Access Compliance Report

Public Rights-of-Way

(Curb Ramps)

Intersection ID: 47978	Main Street: RAFFIA_RD	Cross Street: AVALY_LN	Location: S
ADA ID: F415C21C211A	Ramp Type: PerpDiag	Initial Pass/Fail: Pass	Overall Compliance: No
		Severity Score: 0

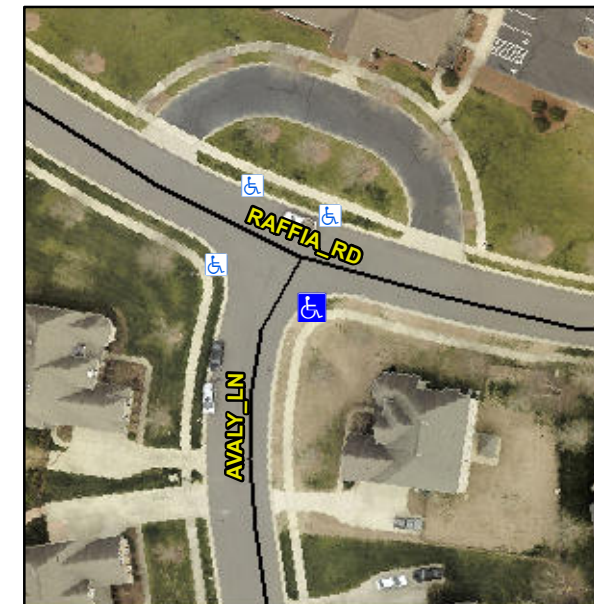
Compliance	Description	Data	Compliance	Description	Data
N/A	Ramp Length (in)	71.0	Yes	Ramp Slope (%)	6.1
Yes	Ramp Width (in)	48.0	Yes	Ramp XSlope (%)	0.9
N/A	Flare Type LT	Sloped	N/A	Flare Type RT	N/A
N/A	Flare Slope LT (%)	6.3	N/A	Flare Slope RT (%)	6.8
N/A	Flare Traversable LT?	No	N/A	Flare Traversable RT?	No
Yes	Landing Length (in)	60.0	Yes	DWS Provided?	Yes
Yes	Landing Width (in)	48.0	Yes	DWS Contrast?	Yes
No	Landing Slope (%)	2.6	Yes	DWS Length (in)	24.0
Yes	Landing X Slope (%)	0.8	Yes	DWS Full Width?	Yes
N/A	Landing Curb? (Y/N)	No	No	DWS Offset (in)	4.5
N/A	Shared Landing?	No			
Yes	Gutter Ponding?	No	Yes	Gutter Slope (%)	0.9
Yes	Gutter Lip Ht (in)	0.0	Yes	Gutter X Slope (%)	0.5
N/A	Painted X Walk1?	No	N/A	Painted X Walk2?	No
	X Walk 1 Direction	To NE		X Walk 2 Direction	To NW
N/A	X Walk 1 Width (in)	N/A	N/A	X Walk 2 Width (in)	N/A
	X Walk 1 Slope (%)	4.0		X Walk 2 Slope (%)	0.5
	X Walk 1 X Slope (%)	0.1		X Walk 2 X Slope (%)	2.3

N/A	Ramp inside XWalk1?	N/A	N/A	Ramp inside XWalk2?	N/A
	Road Slope (%)	0.5	N/A	Clear Space?	Yes
	Road X Slope (%)	3.7	N/A	Clear Space to XWalk (in)	N/A
Yes	Any Obstructions?	No	Yes	Storm Grate/Utility Hazard?	No
	Obstruction Type			Storm Grate/Utility Type	
		N/A			N/A
			Yes	Surface Condition? (G/P)	Good

Remove & Replace Curb Ramp With Two New Directional Ramps or Equivalent.

R304.2.2-Perp, R304.3.2-Para, R305.2
